ADDENDUM NO. 2

**October 4, 2016
Residuals Lagoon
Highway 211 Water Treatment Plant
Brunswick County, NC**

1 RAMP DETAIL
SCALE: 1/2" = 1'-0"

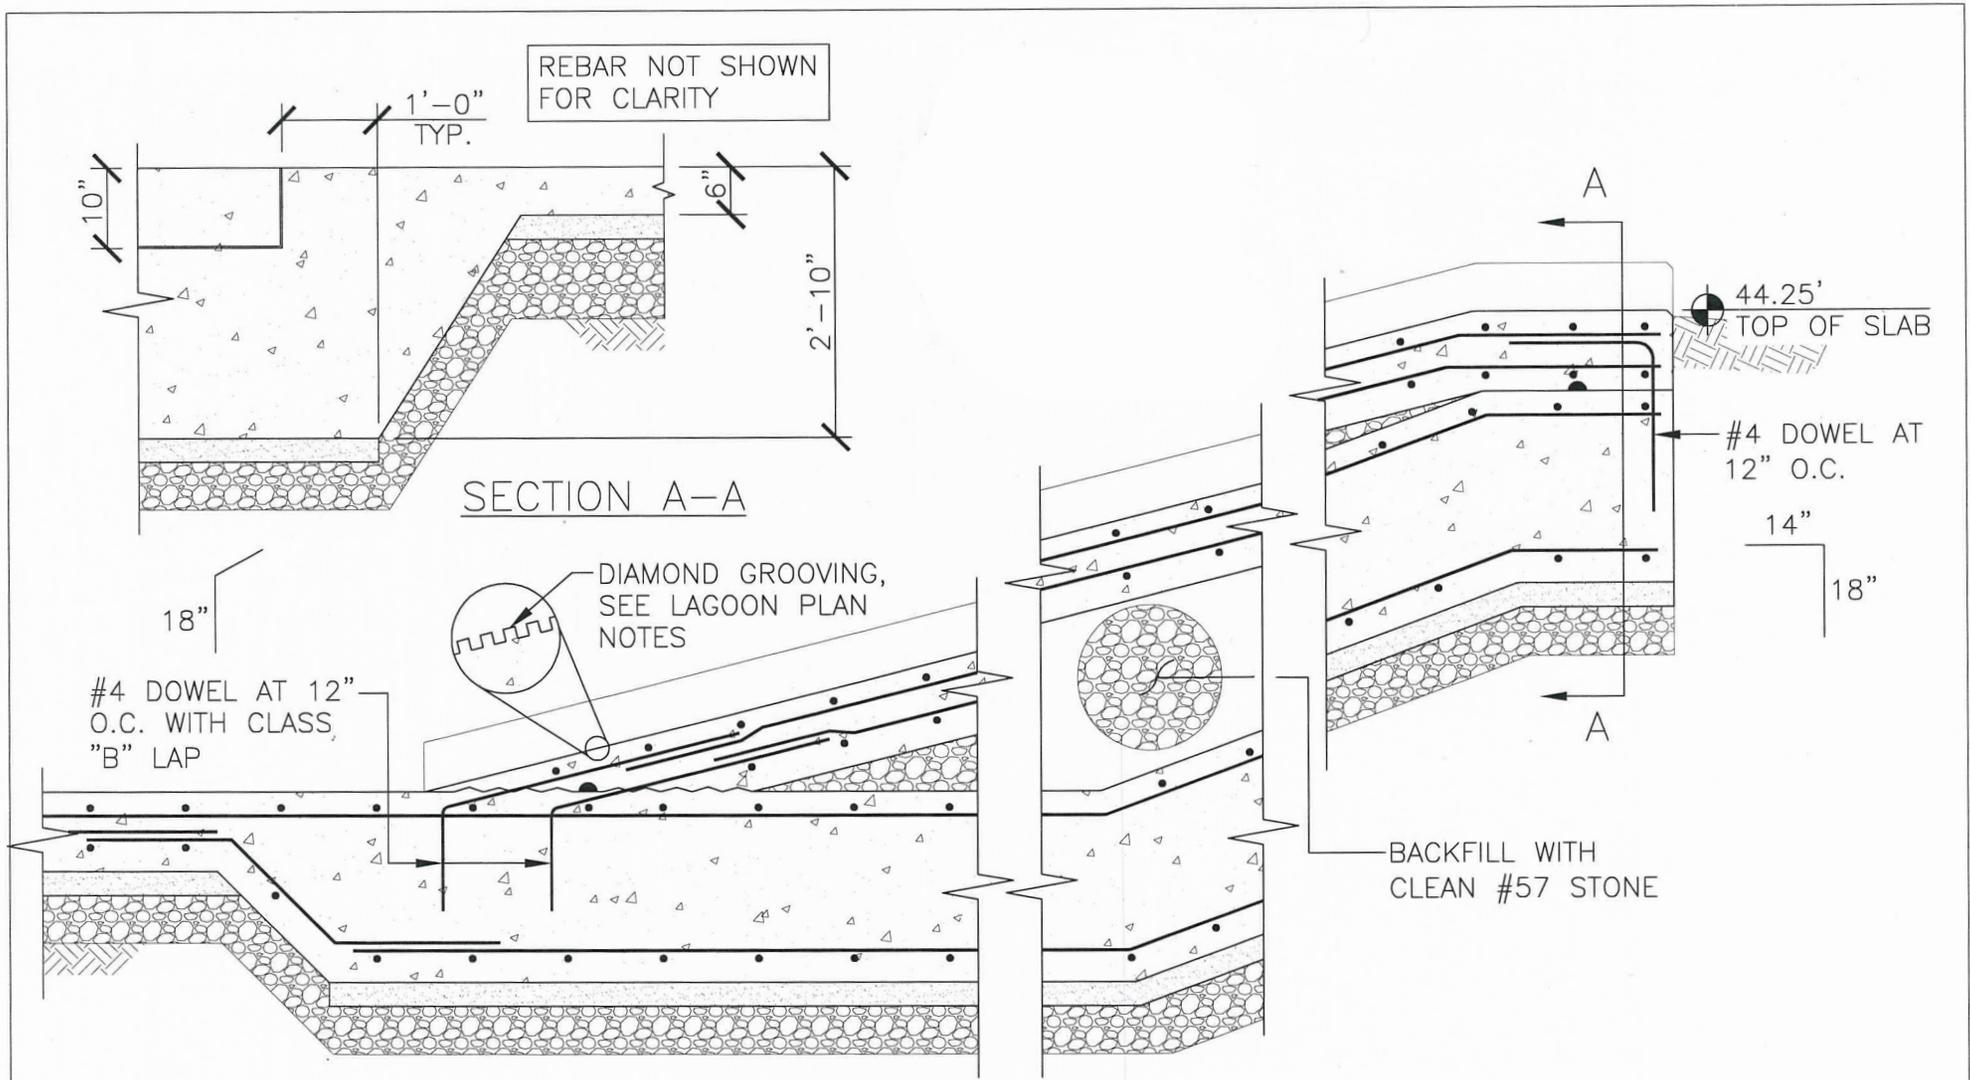
7. Can you provide a section view through the lagoon ramp?

1. **ADD** the attached RAMP DETAIL SK-01 to the Contract Drawings. This detail represents a north/south section view through both ramps.

Please see changes to the CONTRACT DRAWINGS.
